**PLANNING AND ZONING COMMISSION OF JEFFERSON COUNTY, MISSOURI
NOTICE OF MEETING**

Petition Number: PI23011

Petition Number: CC223012

Petition Number: PR123014

PI23011 - A & O Contractors

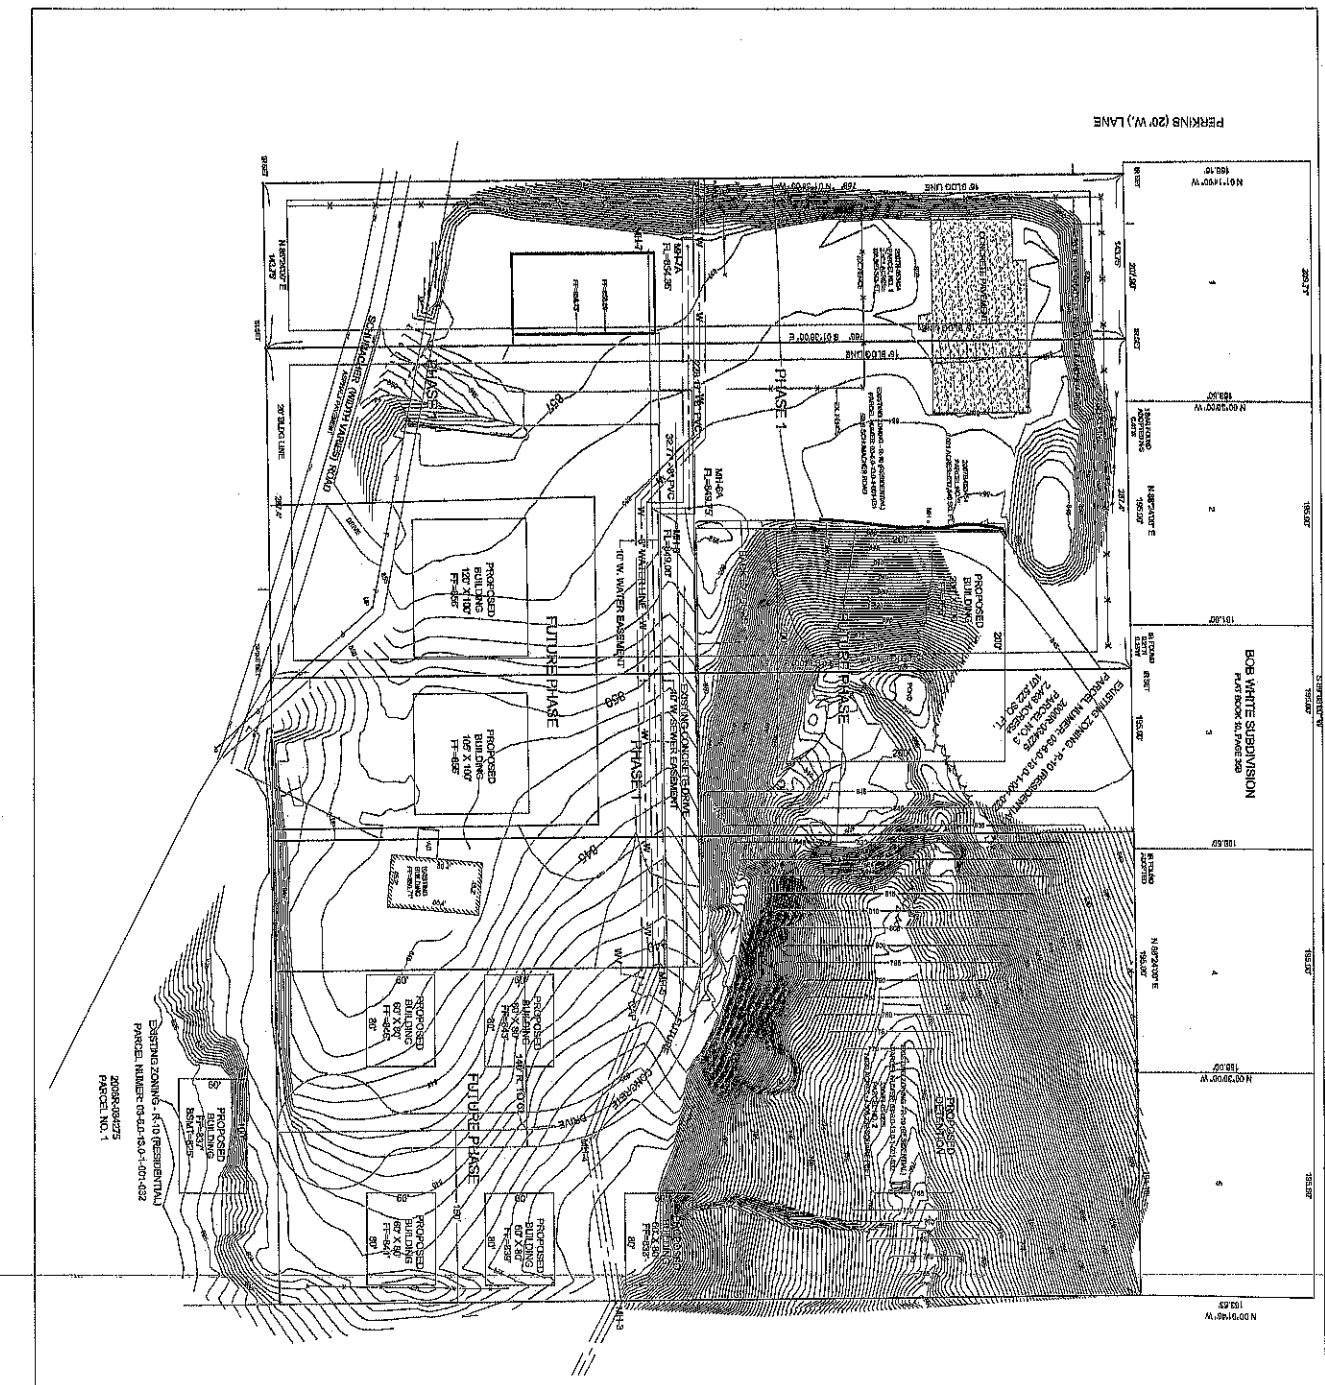
- 1) A boundary line adjustment is required to join the individual parcels into one.
 - a) Should individual lots be desired, the streets would need to meet UDO standards for Planned Industrial zoning per the applicable traffic counts. Also, each lot must be served by a street. All UDO street requirements would need to be met (row width, curvature, etc.). Street requirements, Planned Industrial (1,520-2,000 vehicles per day): Street width shall provide 24' pavement within 30' ROW with curbs. Street thickness shall include 7" PCC/4" rock base (or 2" Type C Asphaltic Concrete/6" Type X Asphaltic Concrete/4" rock base). Streets shall not exceed 12% max grades, 100' horizontal radii, K=30, 100' tangents and 1500' block length.

- 2) Parking areas:
 - a) Parking areas with 5 or more required parking spaces must provide a paved surface of 3" Type C Asphaltic Concrete over an 8" rock base (or 2" Type C Asphaltic Concrete/4" Type X Asphaltic Concrete; or 6" PCC).

- b) Parking areas with 4 or less required parking spaces (and contractors storage yards) must provide an 8" rock base minimum.
 - c) Fire/delivery/freight trucks lanes must be designed to support anticipated loads.

- d) Drive aisles width (boc):
 - i) Drive aisles shall be 24' wide for all 90 degree parking (one-way and two-way).
 - ii) Drive aisles shall be 20' wide for all two-way angled parking (0-60 degree).

- iii) Drive aisles shall be 20' wide for one-way 0 degree and 60 degree (if both sides).
 - iv) Drive aisles shall be 16' wide for one-way for 45 degree and 60 degree (if one side).

- e) Setbacks:
 - i) Commercial and Industrial districts, any parking or loading area visible from a street shall be separated from the street ROW with a 20' landscape strip.

- ii) Industrial developments require at least 20' setback from the ROW and any residential property lines.
 - f) Parking lot spaces shall not be placed in such a manner where vehicles will back into a street.

- g) Straight back curbing (concrete or asphalt) is required around parking areas.
 - h) Pavement shall slope between 1% and 6%.
- 3) Detention:
 - a) Stormwater shall be detained and released at a rate not to exceed the release rate from the site under the existing (pre-developed) conditions for the 2 and 100-year storm events. Detention/retention basins must also contain an overflow structure capable of passing a 100-year, 20-minute design storm.

- b) Channel protection is required to treat the high-frequency, low-severity storm runoff events within the detention basins by metering it out slowly over 24-48 hours.

- c) Stormwater system shall be designed for the 15-year, 20-minute event. Provide hydraulic calculations and drainage area map for each system.
- 4) Grading:

- a) Submit a geotechnical report, sealed by an Engineer registered in the State of Missouri, as required where more than 5' of cut or 5' of fill is proposed. Grades at slopes proposed steeper than 3:1 must be included in the report for slope stability.

- b) Walls over 6' require a permit from the Building Division.

- There looks to be an existing earth entrance to the east of the new entrance. This will need to be removed as it is too close to the new entrance to remain in place.
- A traffic study is recommended to determine if any lane additions/extensions are needed based on the proposed development traffic generation.

- The developer and all subcontractors must comply with the requirements of Chapter 700 Code of Ordinances for utility locations and relocations within County right of way.
- The new entrance must meet current UDO standards for the new uses of the development.
